Project	IEEE 802.16 Broadband Wireless Access Working Group < http://ieee802.org/16 >	
Title	In-band Non-transparent Relay Frame Structure	
Date Submitted	2006-03-14	
Source(s)	<p>Kanchei (Ken) Loa, Yi-Hsueh Tsai, Yung-Ting Lee, Chih-Chiang Hsieh, Shiann-Tsong Sheu, Hua-Chiang Yin, Frank C.D. Tsai, Youn-Tai Lee, Heng-Iang Hsu Institute for Information Industry 8F., No. 218, Sec. 2, Dunhua S. Rd., Taipei City, Taiwan.</p> <p>Hang Zhang, Peiying Zhu, Mo-Han Fong, Wen Tong, David Steer, Gamini Senarath, Derek Yu, Mark Naden, G.Q. Wang Nortel 3500 Carling Avenue Ottawa, Ontario K2H 8E9</p> <p>Gang Shen, Kaibin Zhang Alcatel-Lucent, Research & Innovation 388#, Ningqiao Road, Shanghai, China.</p> <p>[add co-authors here]</p>	
		<p>Voice: +886-2-2739-9616 loa@iii.org.tw</p> <p>Voice: +1 613 7631315 WenTong@nortel.com pyzhu@nortel.com</p> <p>Voice: 86-21-58541240-8194 gang.a.shen@alcatel-sbell.com.cn</p>

In-band Non-transparent Relay Frame Structure

Figure yyy—Example of minimum configuration for an in-band non-transparent relay frame structure

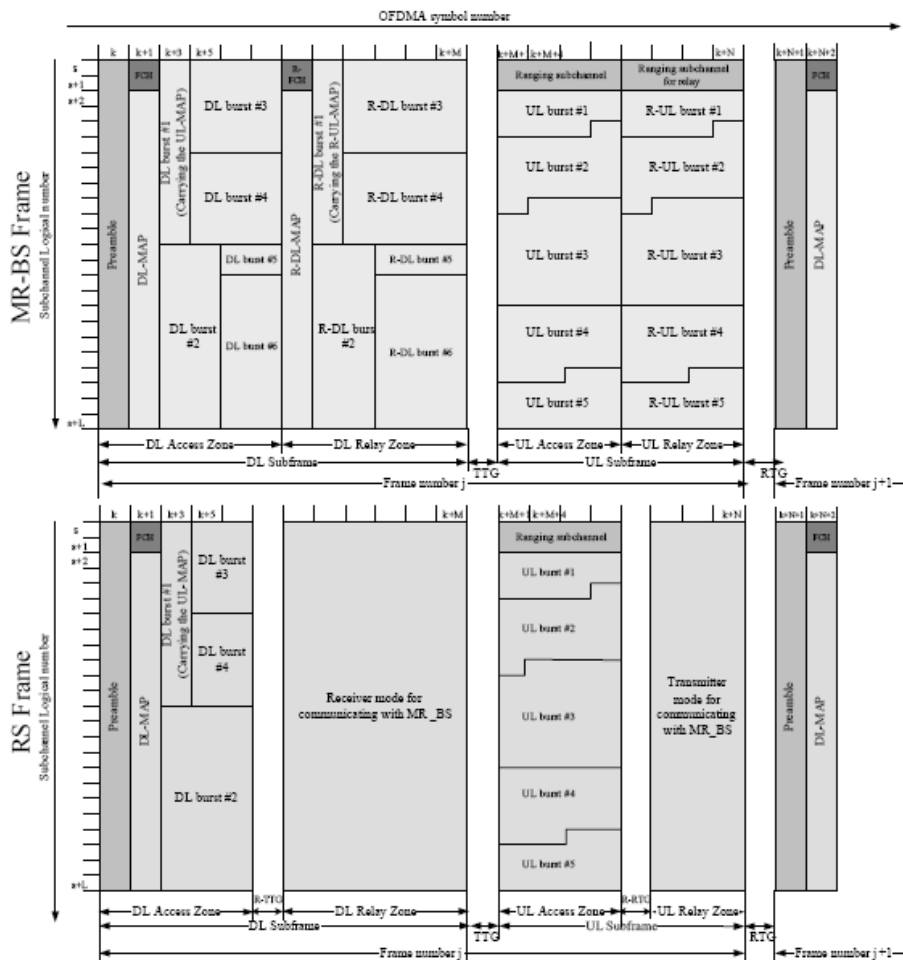
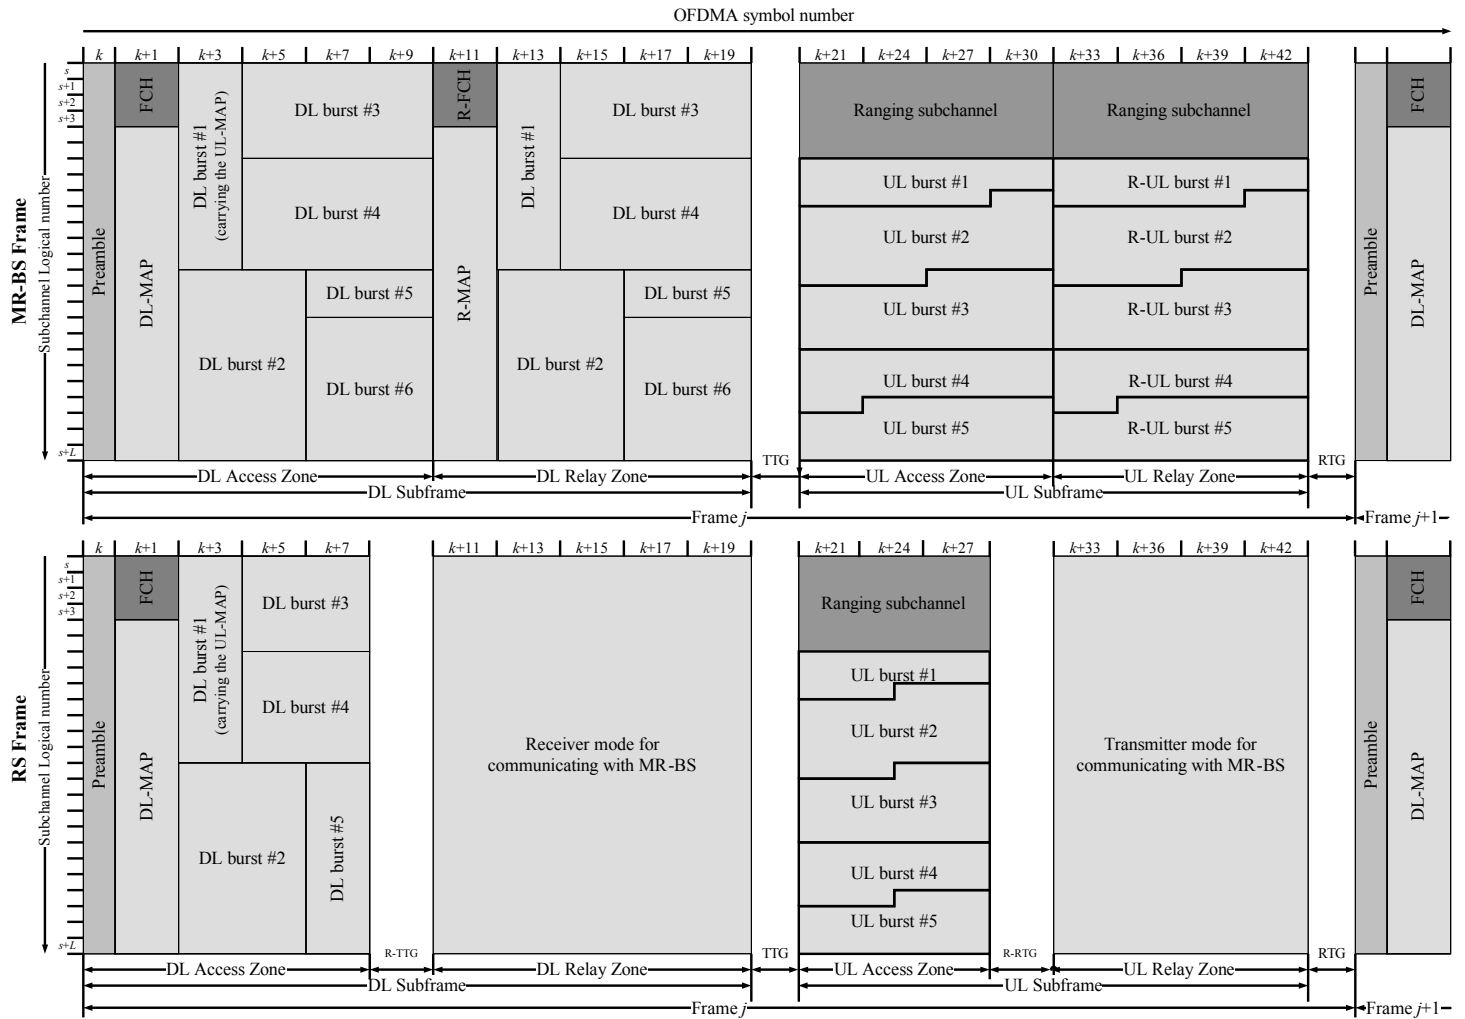
[Change the figure in section 8.4.4.7.2 “Frame structure for non-transparent mode” as indicated:]

[Replace Figure xxx with Figure yyy as follows:]

~~Figure xxx—Example of minimum configuration for an in-band non-transparent relay frame structure~~
